<b>Project title</b>	RFD 2022 Major Flood Model Update Stanley River and Neurum Creek (SRN) Catchment
<b>Job number</b>	305456-00
<b>File reference</b>	Peer Review Technical Note
<b>cc</b>	Alana Mosely
<b>Prepared by</b>	Greg Rogencamp, Kok Keng Tan
<b>Date</b>	3 February 2025
<b>Subject</b>	Independent Technical Review – Technical Note

Subject Flood Model Review Checklist

<b>Project Name</b>	RFD 2022 Major Flood Model Update Stanley River and Neurum Creek (SRN) Catchment	<b>Date</b>	13/1/2025
		<b>Version</b>	2

Water Level Difference: 0.1% AEP (Critical Event at NEU001\_07434 - Adopted Event at NEU001\_07434)

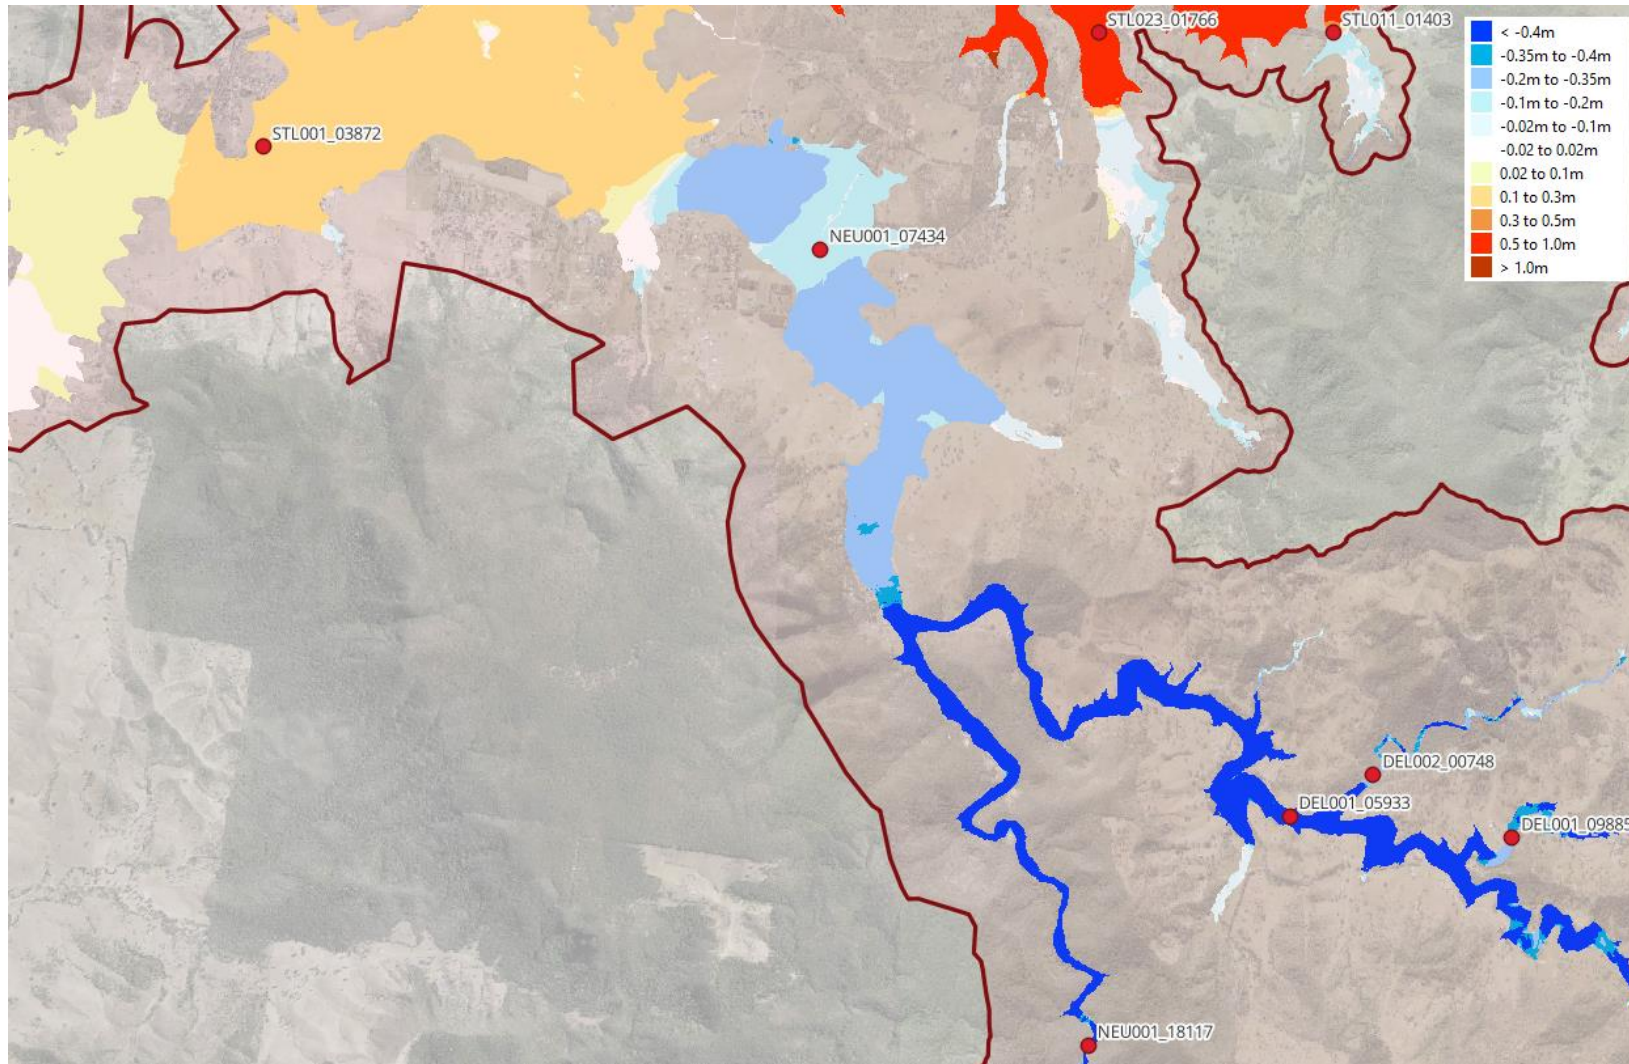
Check Item	Reviewer Comments	Designer Response	Rank	Reviewer Closeout
		<p data-bbox="1283 344 1749 405">difference between the two durations in this area.</p> <p data-bbox="1283 443 1603 475"><b>RE Peak Flow difference;</b></p> <p data-bbox="1283 480 1787 746">Council accepted a tolerance of +/- 10% difference in peak flow between the adopted and critical event at each HEH point, in acknowledgement that a hydrology model cannot exactly replicate conditions captured by a hydraulics model. This target range was achieved for most points in the SRN model.</p> <p data-bbox="1283 785 1778 1187">No HEH points had an underprediction outside of the accepted range (STA001_13561 had a maximum underprediction of -6%, which was within target range). Some points exceeded this range by a small amount, and in these instances, commentary has been provided in the modelling report to explain and justify. In general, a conservative model which overpredicted flow at a point was seen as preferable to a model which underpredicted flows.</p> <p data-bbox="1283 1225 1783 1423">Only one HEH point (NEU001_07434) featured a large overprediction in flow (overestimates at this POI ranged from 15-24%). A sensitivity has been undertaken, running the adopted event and critical event at NEU001_07434 in</p>

Check Item	Reviewer Comments	Designer Response	Rank	Reviewer Closeout
		<p>TUFLOW for the 0.1% AEP, to see how peak water level changes when adopting an event with a 22% over-estimate. The results of this comparison are shown in APPENDIX F. By adopting an overpredicting event at the POI, the following was noted:</p> <ul style="list-style-type: none"><li>• There was approx. 180mm increase in peak water level as compared to the critical event at the POI location.</li><li>• There was up to approx. 350mm increase in peak water level as compared to the critical event at areas upstream and downstream of the POI location.</li><li>• Further upstream in the narrower well-defined reaches of Neurum Ck and Delaney Creek, differences over 350mm were identified. However, it is noted that the comparison results become less relevant when moving further upstream from NEU001_07434 and closer to other HEH points (DEL001_05933 and NEU001_18117) where the critical duration changes. The same can be said downstream of NEU001_07434 where flooding from the Stanley River becomes the critical event.</li></ul>
